RESPONSES TO JULY 9, 1984 DNR COMMENTS ON THE NOISE REPORTS

EXXON MINERALS COMPANY
CRANDON PROJECT

OCTOBER 31, 1984

(FIGURE 1 FOR THE RESPONSE TO COMMENT NO. A13)
NOISE LEVEL ESTIMATES FOR NIGHT CONSTRUCTION ACTIVITIES

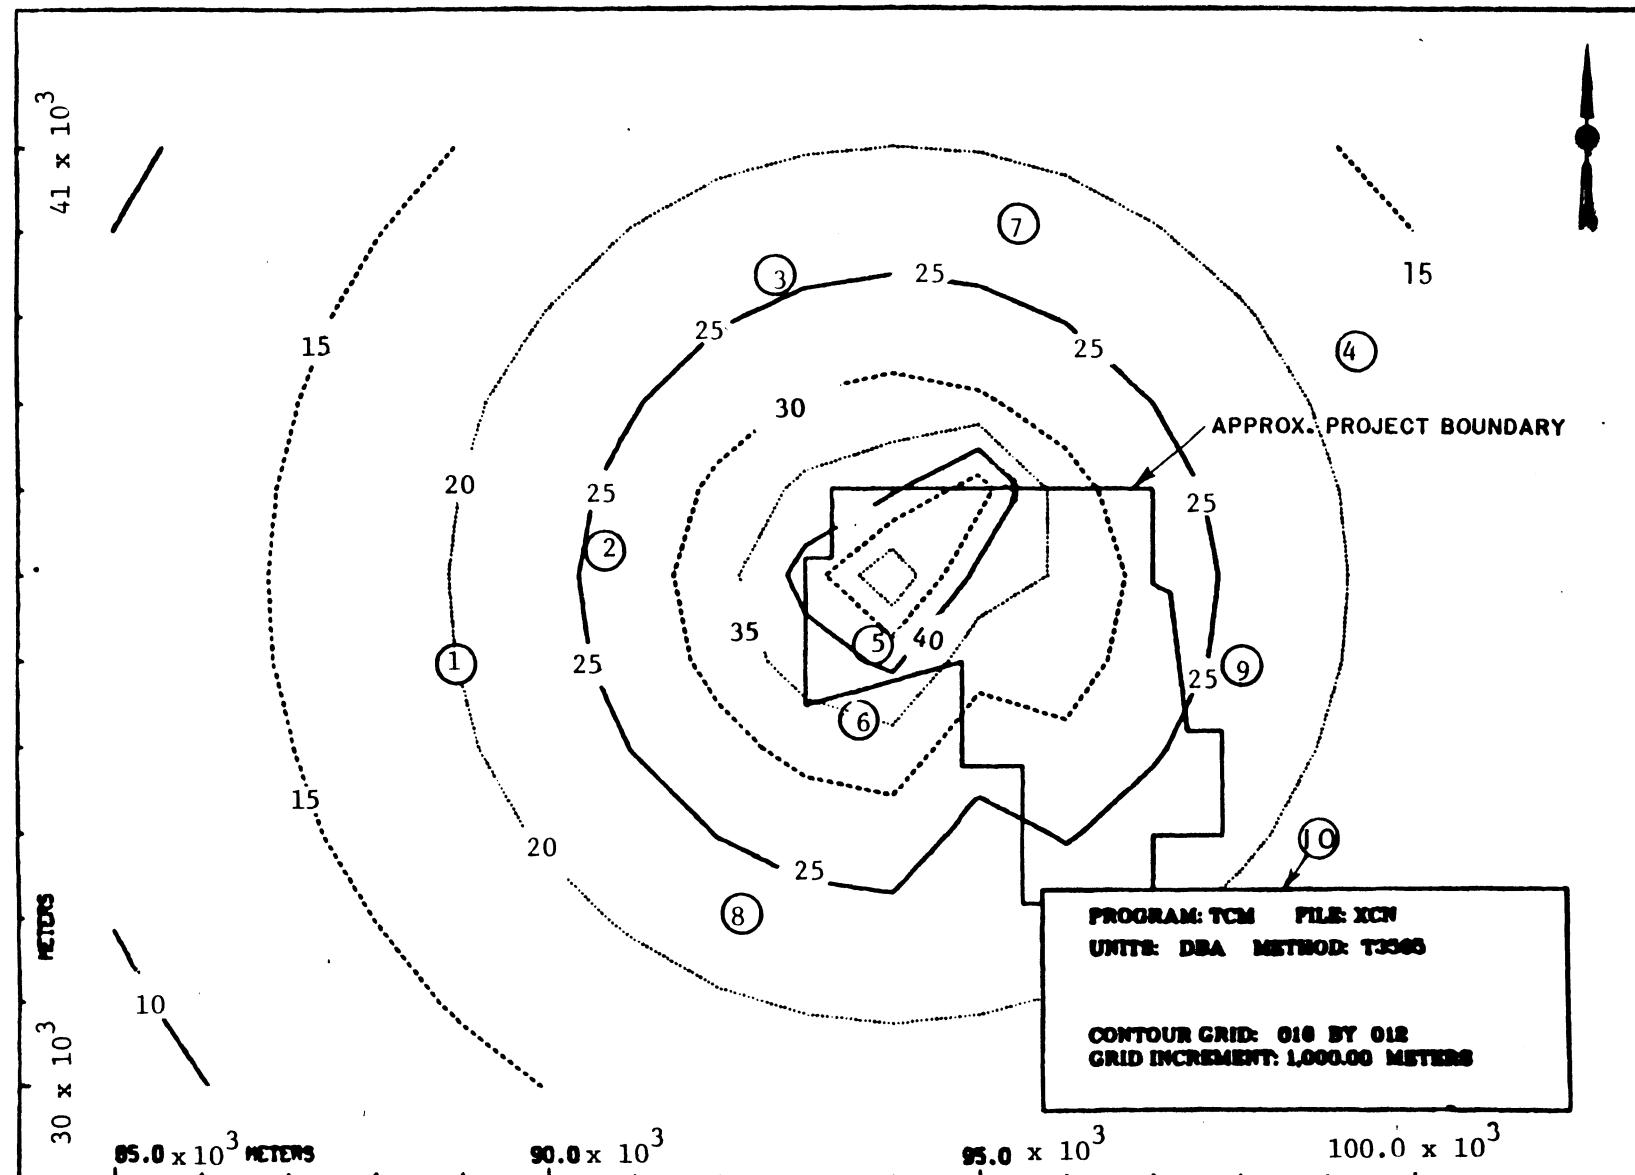
To avoid future questions from the public, it would be advantageous to estimate existing noise levels and impact at other areas based on the data at the ten monitoring sites. Even though impact is clearly identified and represents the impact for the whole area, questions will most likely arise why some areas were not assessed for impact.

Estimated noise levels from construction and operation activities at the ten original sampling locations (1-10), the three additional locations (A-C), and at other undefined locations in the environmental study area are presented in the attached Figures 1 through 3. These figures illustrate the property boundary site and area with isopleths of A-weighted equivalent (L_{eq}) sound pressure levels. Existing (ambient) noise levels are not included in these figures. The modeling basis for these estimates is described in the response to comment No. A17.

CRANDON BLASTING VIBRATION ESTIMATE PEAK PARTICLE VELOCITY MODEL

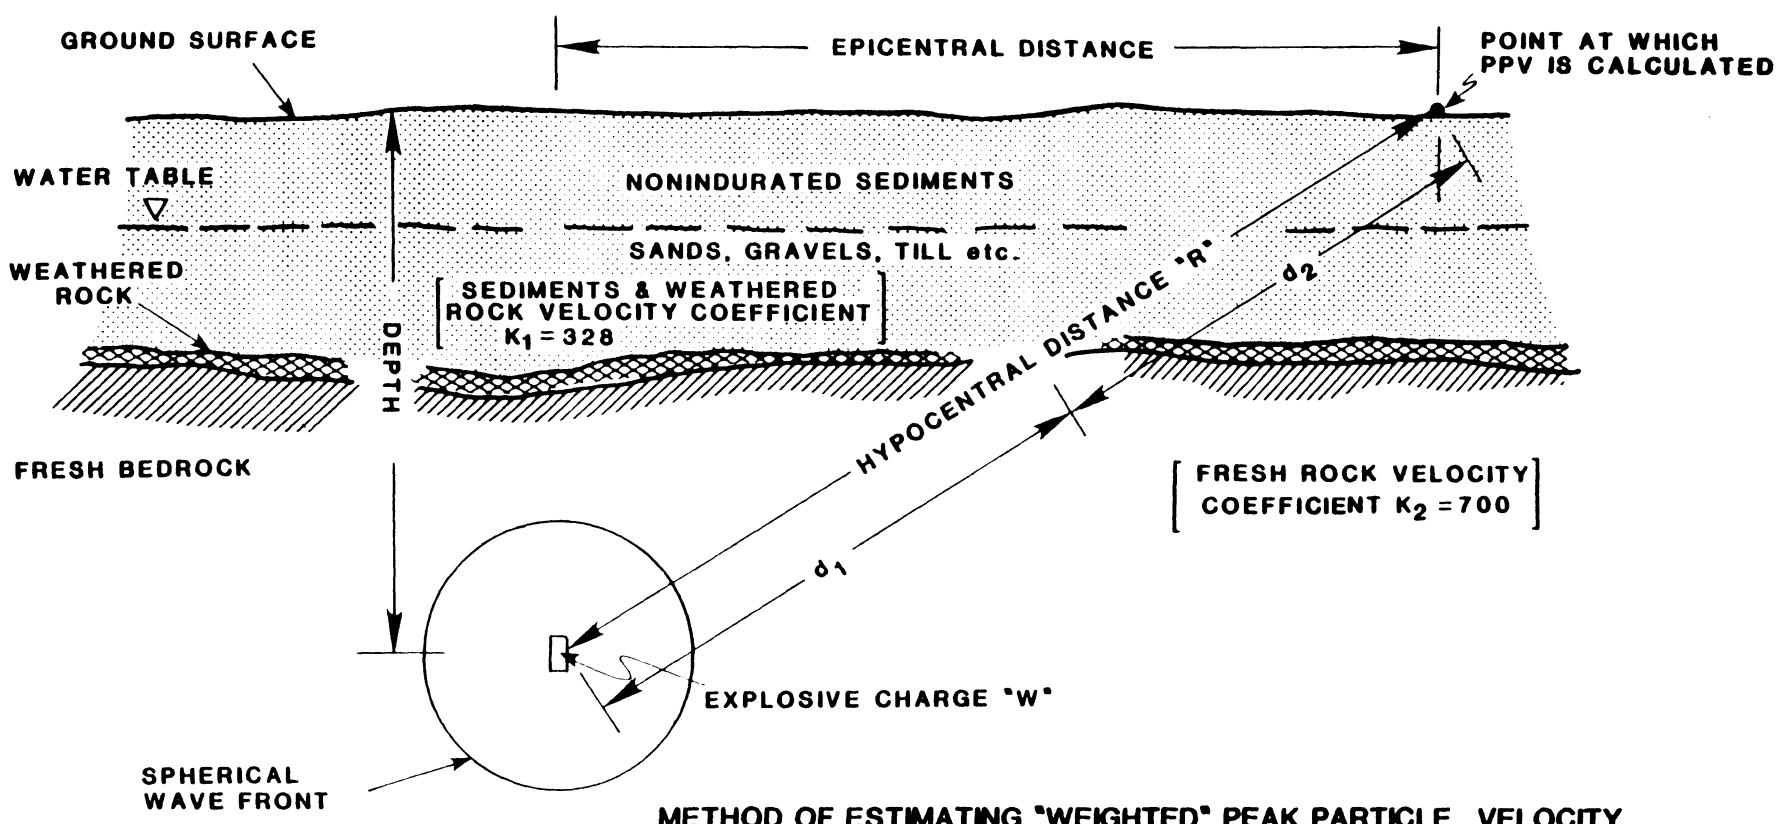
- c) Experimental plan: location, amount of explosive sensor locations, and results. In the experimental methods, test blasts with measuring devices could be used to predict what full-scale blasts will do. This would be the preferred method, regardless of whether there is any prediction on the basis of other methods. Due to the many unknowns and assumptions that would have to be made in calculations, some sort of proof by experiment is deemed required for dependable DNR evaluation of the submittals.

Peak particle velocities were estimated by utilizing an empirical relation which accounts for the distance from the charge, the weight of charge, and the character of the media through which the stress wave travels (see Figure 1 attached). The assumed material cross section is a two-layer model consisting of 50 m (164 feet) of nonindurated sediments (i.e. sand, gravels, glacial till) and weathered rock which rests on fresh Precambrian volcanics and massive sulfide ore. The weathered rock contact was modeled at a depth of 25 m (82 feet), establishing the location for initial shaft blasting. The materials model was developed by synthesizing available geologic data and site refraction seismic survey data acquired by Geoterrex Ltd. for the Crandon Project.

FIGURE NO. 8

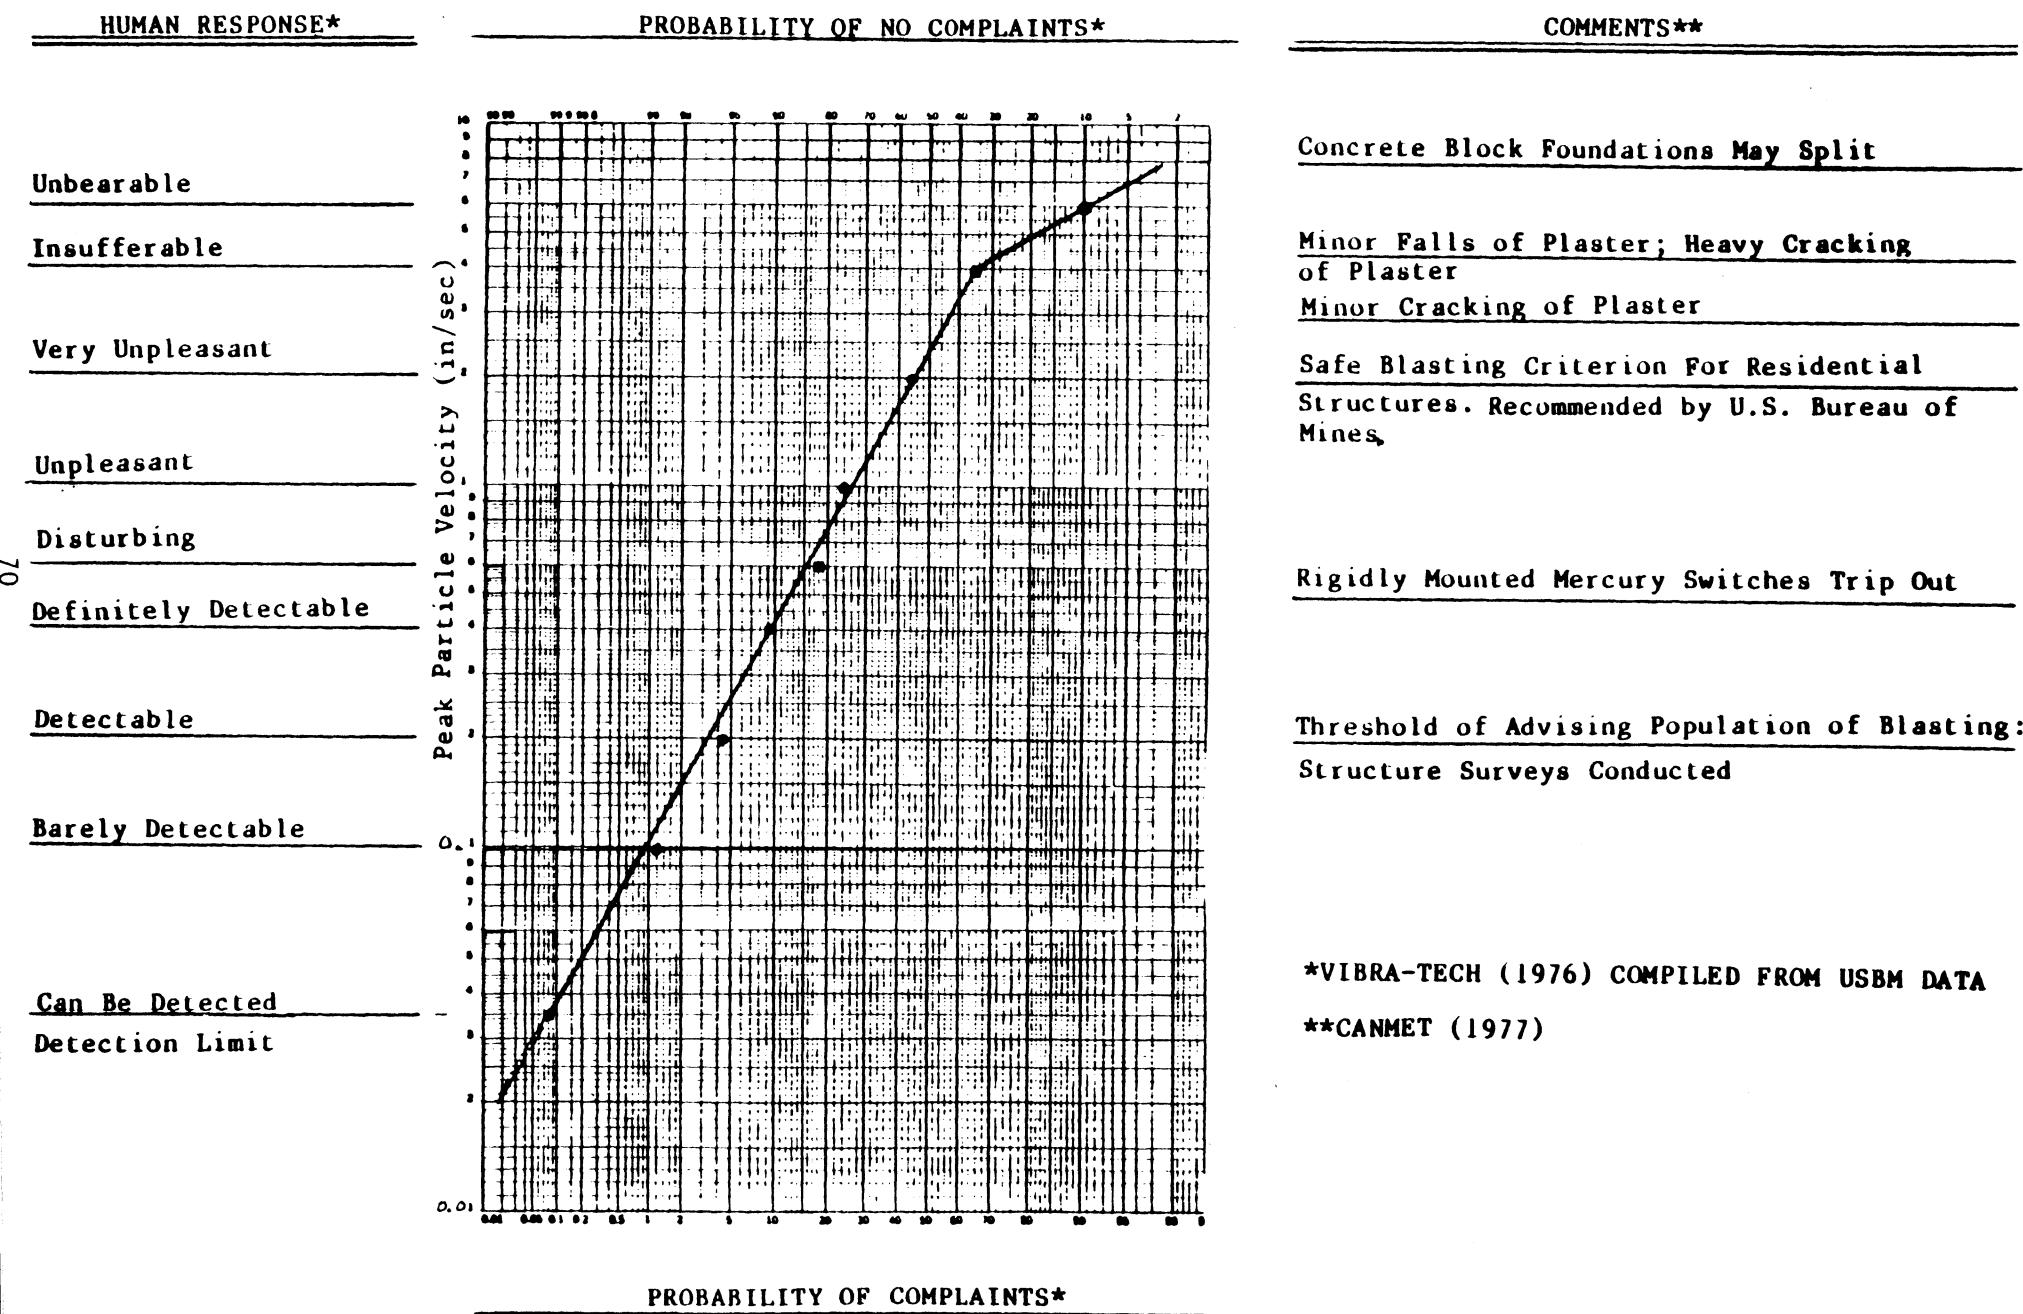
Figure No. 8 on p. 70 indicates that structure surveys should be conducted when vibrations exceed 0.2 in/sec. Predicted vibrations at 1/2 mile exceed this criteria. Exxon should expand the area of the pre-blast survey beyond the proposed 1/2 mile to include those structures which will experience vibrations above 0.2 in/sec.

Data on human response to peak particle velocity were compiled from information provided by Vibra-tech (1976). The Vibra-tech data are based on field and laboratory studies conducted by the USBM and other sources (see Figure 8 attached). Combined with the human response information are comments on structural effects as summarized in CANMET (1977).

(FIGURE 1 FOR THE RESPONSE TO COMMENT NO. 2)

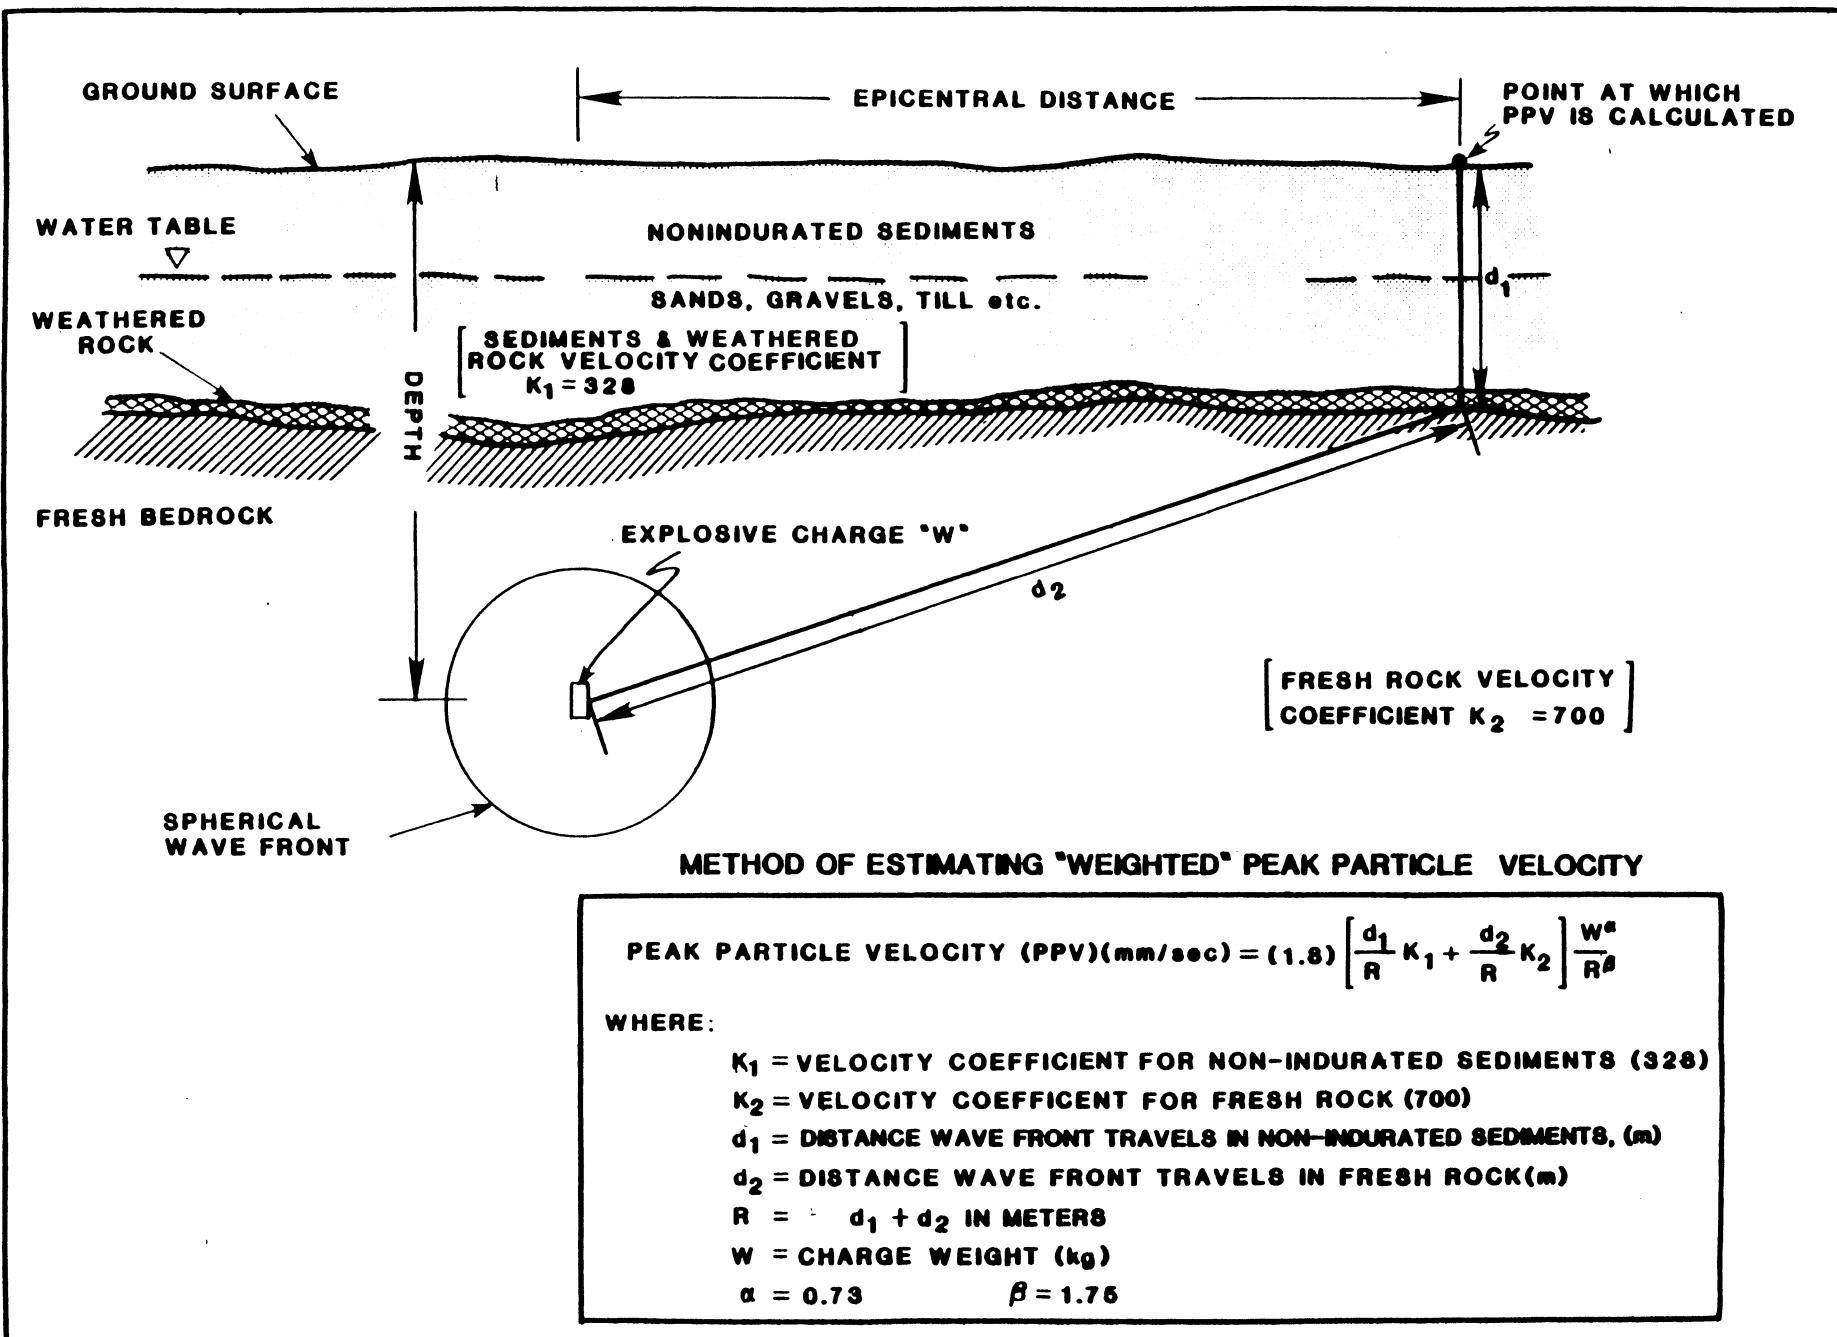
The analysis method is depicted on p. 61 of the October 31, 1984 responses. While the method is correct, its application is not. It is assumed that blast vibrations will travel in a straight line from the point of explosion to the ground level receptor. In fact, vibrations move a greater distance through the bedrock before traveling through the overburden. This causes surface vibrations to be greater than predicted using Exxon's approach. Since off-site vibrations were shown to be detectable, the analysis should be adjusted to account for this phenomenon. This subject is discussed further in "Vibrations of Soils and Foundations" by Ricardi.

Projected blast vibrations have been recalculated using a bilinear shock wave path as illustrated in the attached Figure 1. The resulting calculated ground surface peak particle velocities (PPV) for four cases of production blasting, on the 95 m, 140 m, 290 m, and 640 m mining levels, are presented on attached Figures 2 through 9 as both linear and log-log relationships. Previously calculated PPV for shaft sinking operations showed values well below the detectable limit of 0.89 mm/s (0.035 inches/second) at distances exceeding 500 m (1,640 feet). These values were confirmed using the bilinear approach for the same distance and are presented below:
